# BUILDING PERMIT

Located At 59 BRAMBLEWOOD DR

Job ID: 2012-06-4143-SOB

has permission for an exterior addition of a porch/ roof (Single Family Residence),  
provided that the person or persons, firm or corporation accepting this permit shall comply with all of the provisions of  
the Statutes of Maine and of the Ordinances of the City of Portland regulating the construction, maintenance and use of  
the buildings and structures, and of the application on file in the department.

# Elevations

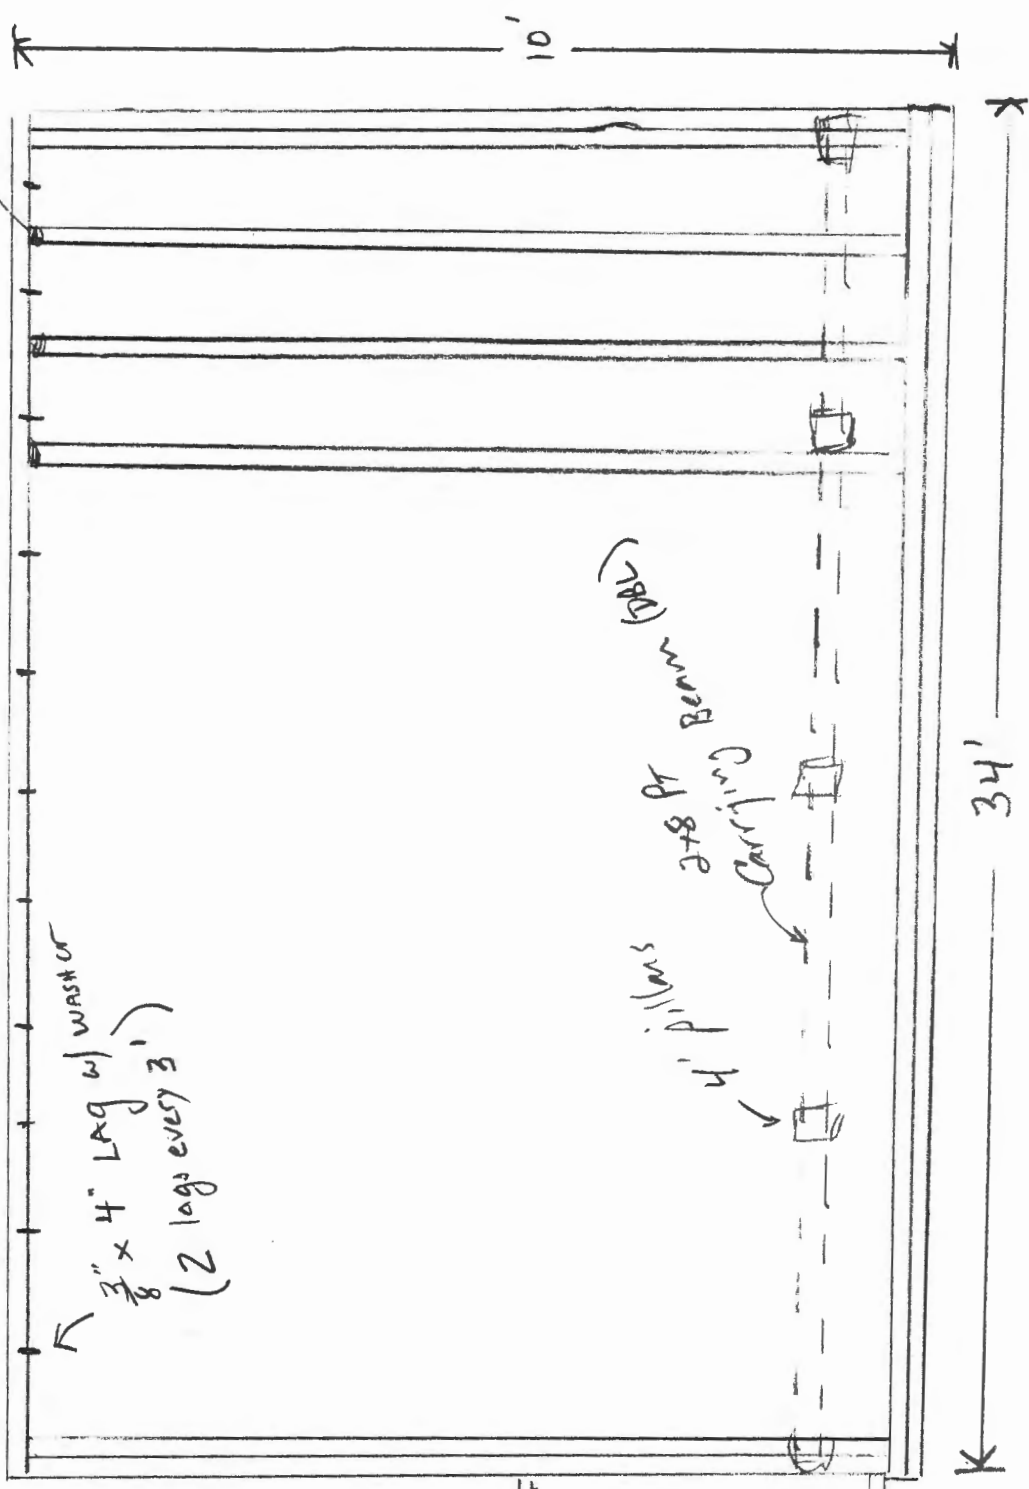
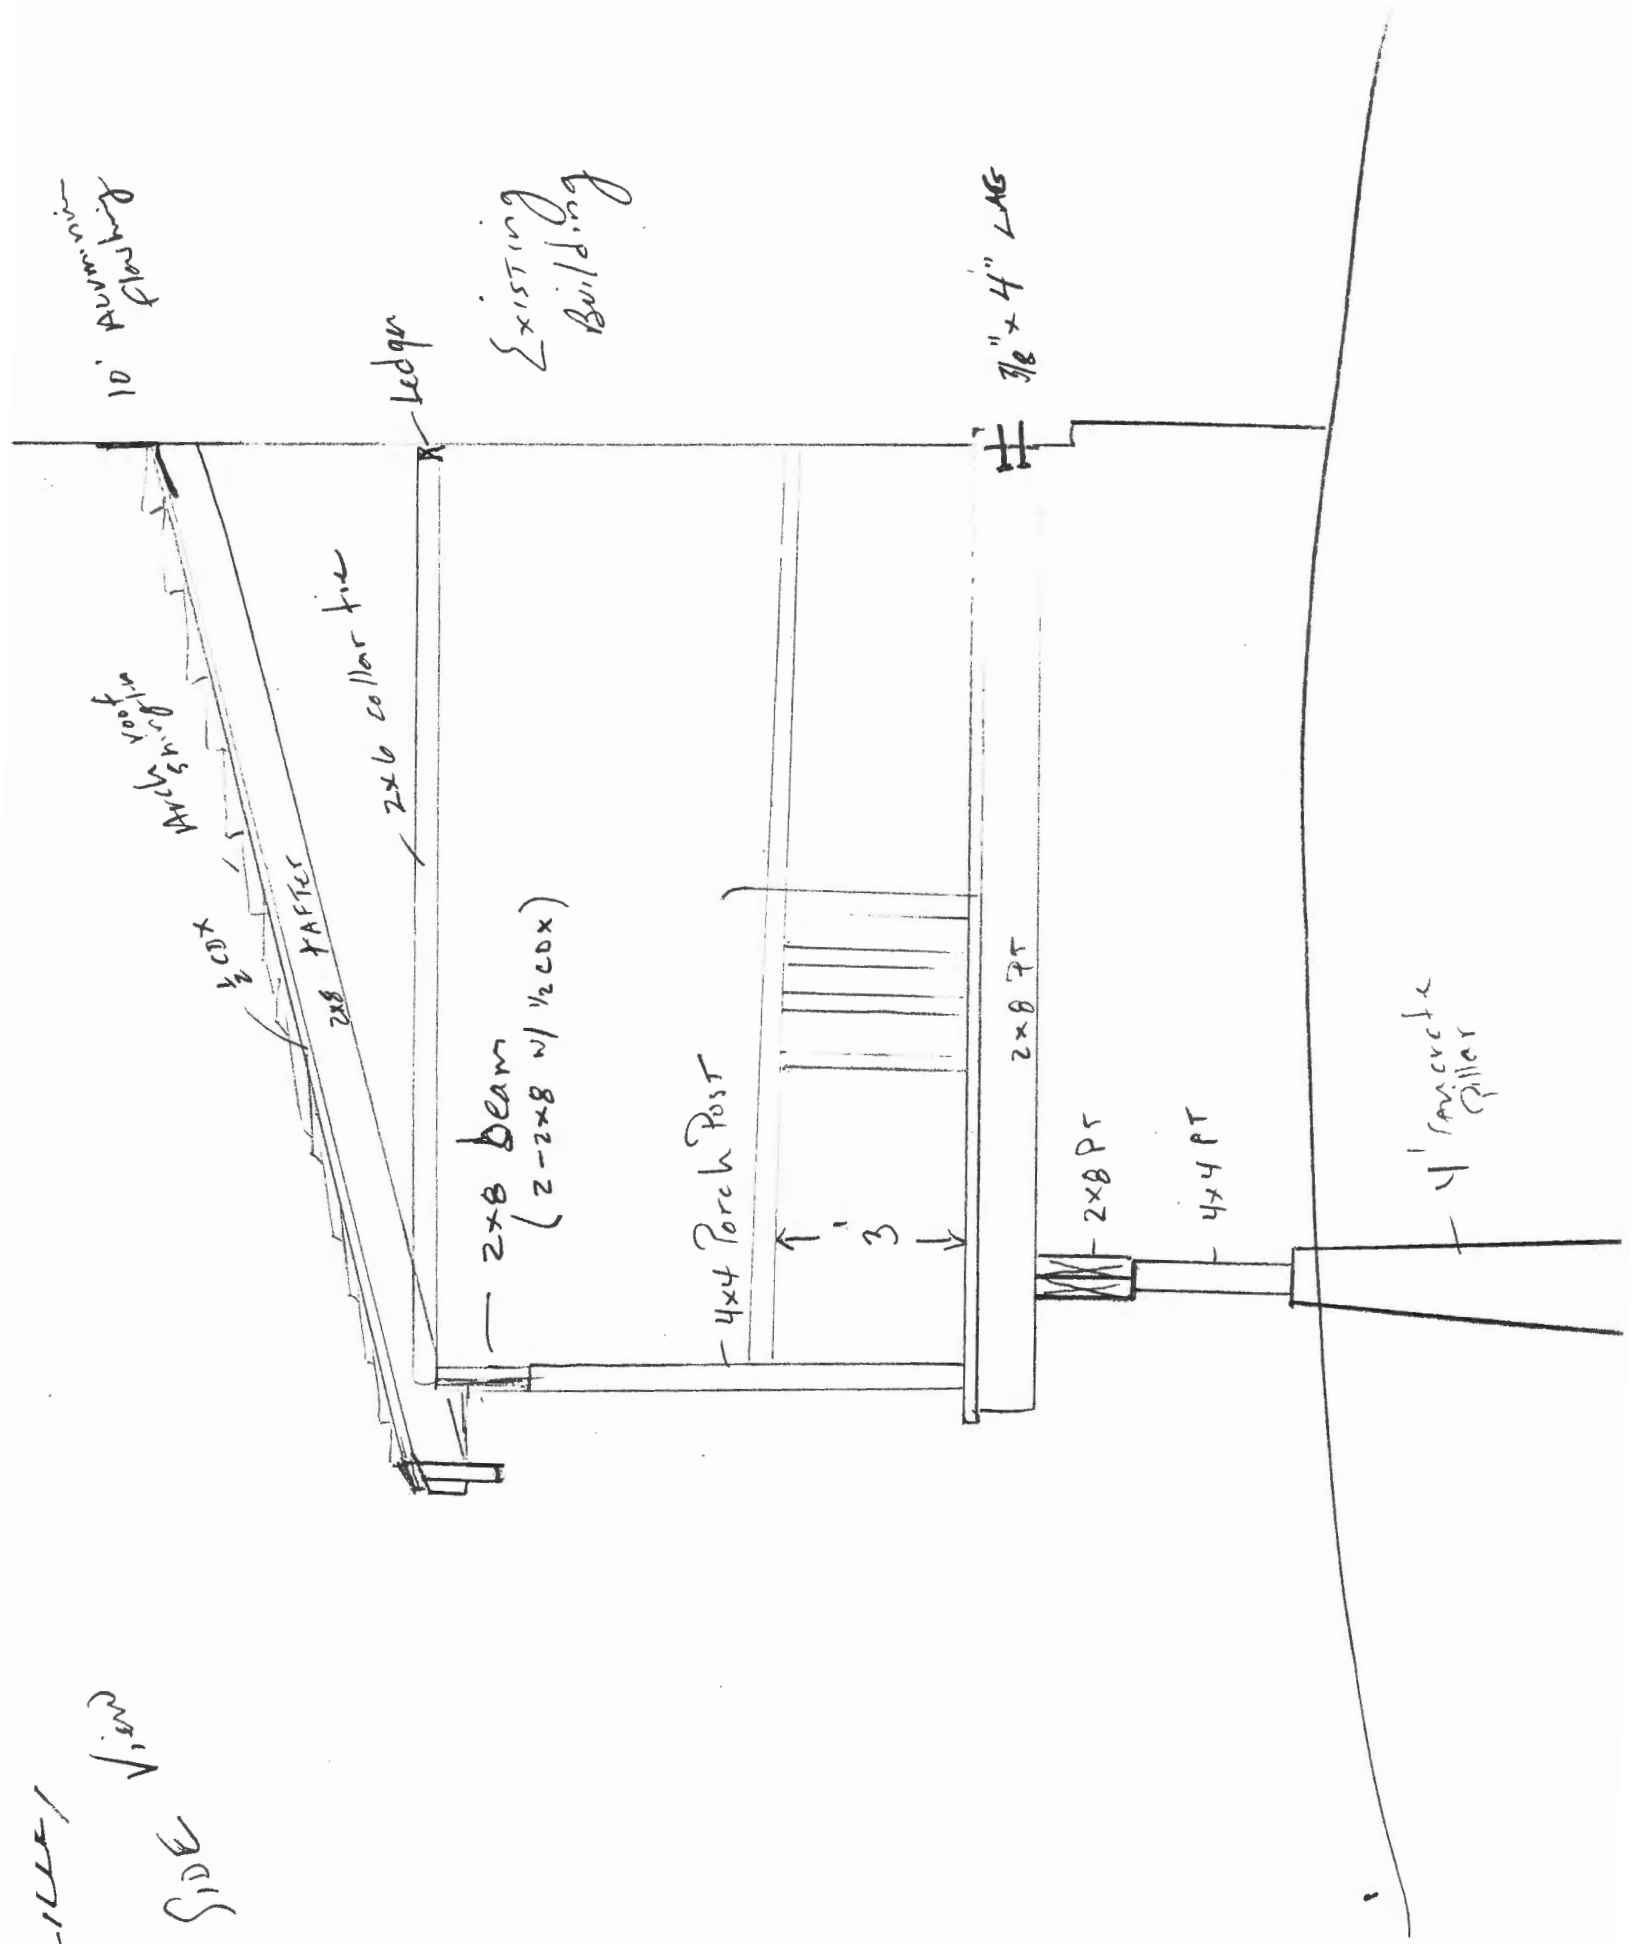
5. Roof Rafter framing and Connection shall comply with Section R802.3 & R802.3.1 of MUBEC.
6. R502.6 Bearing. The ends of each joist, beam or girder shall have not less than 1.5 inches of bearing on wood or metal and not less than 3 inches on masonry or concrete except where supported on a 1-inch-by-4-inch ribbon strip and nailed to the adjacent stud or by the use of approved joist hangers.

7. A **graspable handrail** (34-38 inches in height) shall be provided on at least one side of each continuous run of treads or flight with four or more risers. Fall protection (36 inches) from exterior decks may be required if floor joist are at or above thirty (30) inches from grade.

8. **Note: Contractor agreed that all the Header/ Girder Spans will comply with Table R502.5(1), see attachment. The maximum riser height shall be 7 3/4 inches; the minimum tread depth shall be 10 inches.**
